Memorandum of: NCC 2022 Section J4 - DTS Compliance

Project Name: Tamworth RAC

RE: NCC 2022 Section J4 – Preliminary Evaluation

1 GROUND FLOOR PLAN
1:200

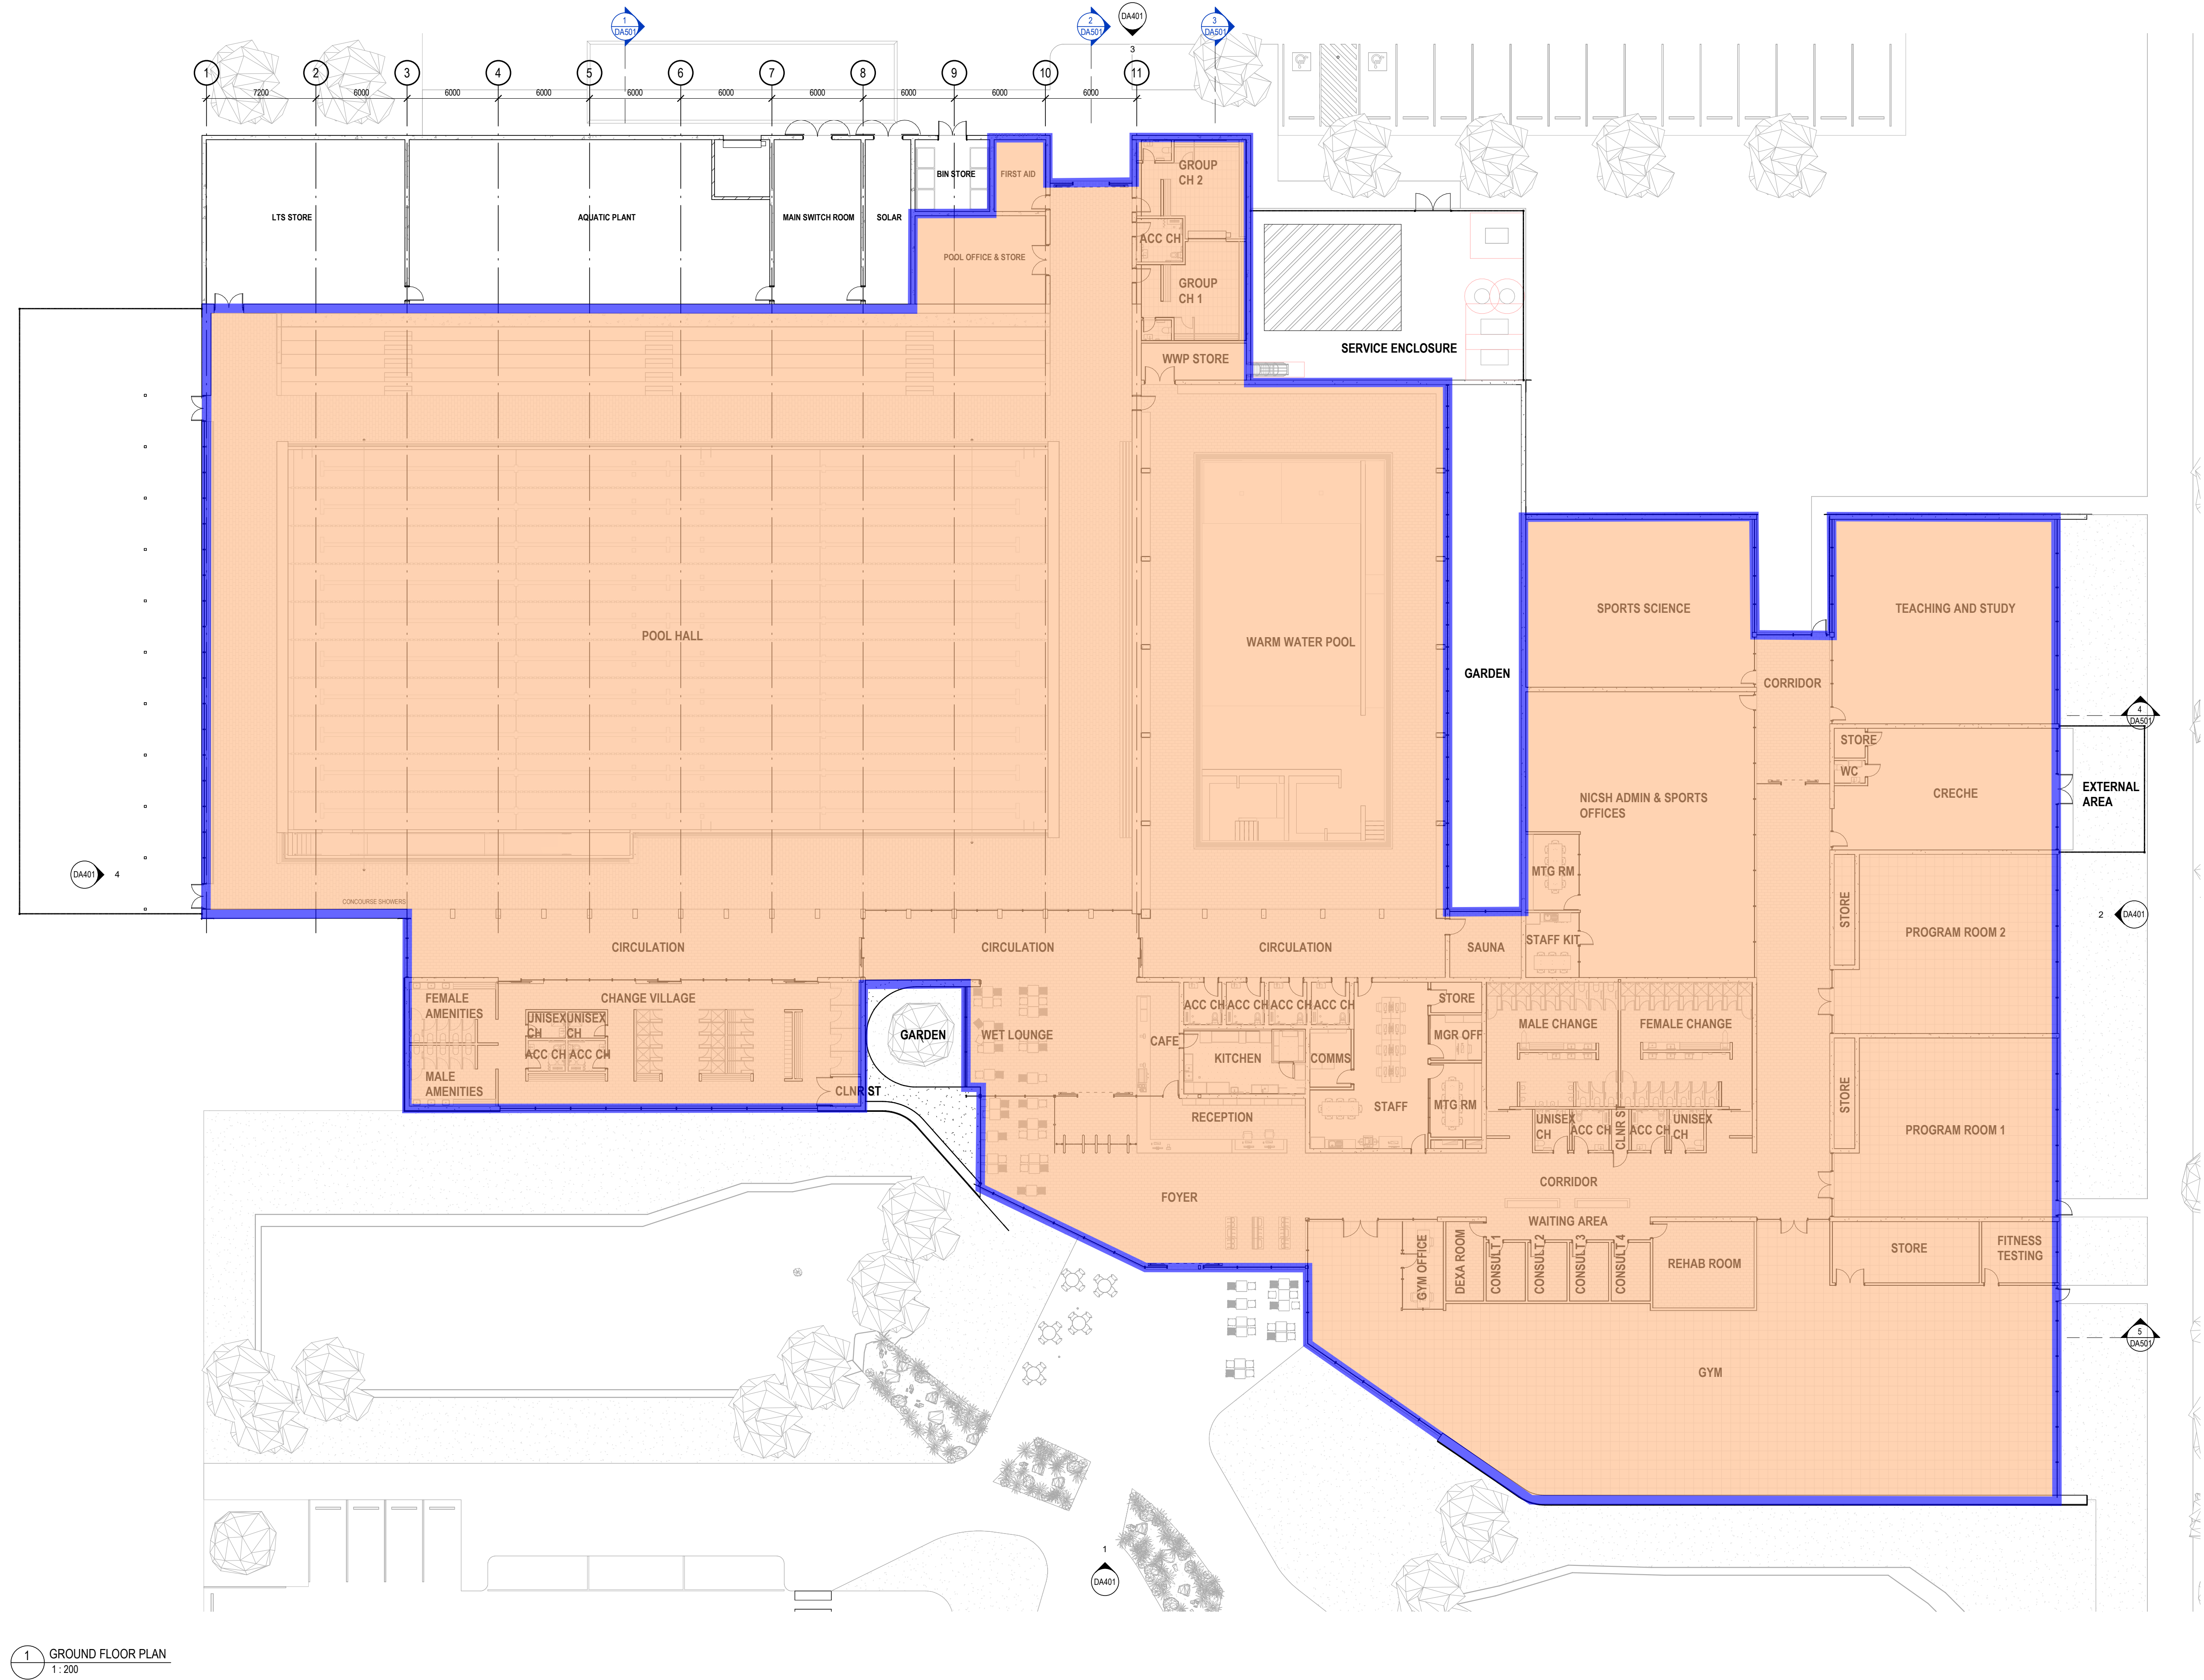
Thermal Envelope Markup - Section J4

Key Building Fabric

- Wall-glazing to comply
- Roof to comply
